# PLANNED UNIT DEVELOPMENT & SURDIVISION STAFF REPORT

**DEVELOPMENT NAME** Pesnell Subdivision, Resubdivision of Lot 1

**LOCATION** 2260 Pesnell Court

APPLICATION NUMBER 23 & 24 DATE August 2, 2007

### SITE PLAN

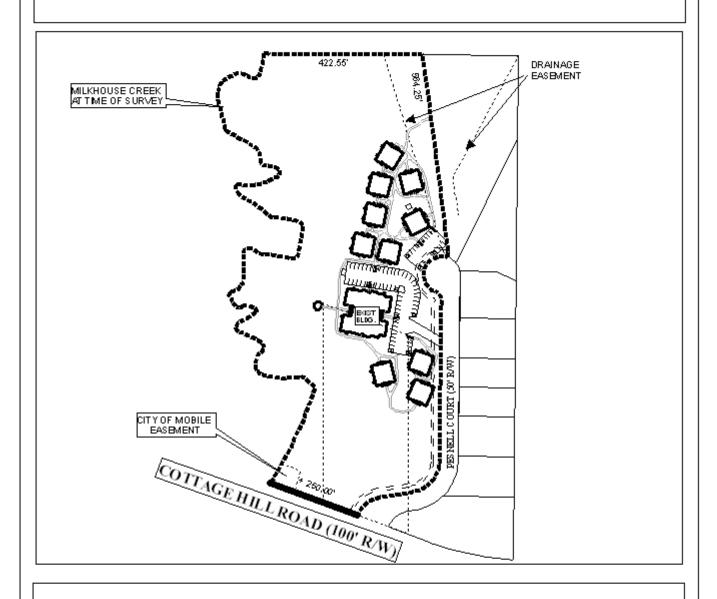
The existing location of the two structures as surveyed is not consistent with previous approvals granted by the Planning Commission. The single issue regarding this application is that the existing structures were constructed within the front setback along Pesnell Court, and are not according to the approved subdivision plat and approved Planned Unit Development. The applicant states that this error was caused by the initial street layout; as the engineer chose to move the street westward some 10-feet to allow the topography on the east side of Pesnell Court to be more conducive for senior citizens who reside there, and simply did not adjust the building location.

It is illustrated by the survey, the structures were built within the front setback and it would seem the equitable solution is to change the front setback to allow the two structures to remain. However, the plat should be revised to place the 18-foot front yard setback only where these two structures are built along Pesnell Court.

1) that the front setback be adjusted on the Final Plat allowing an 18-foot minimum building setback along Pesnell Court only where the two existing structures are located and 25-foot minimum building setback along the remaining frontage.
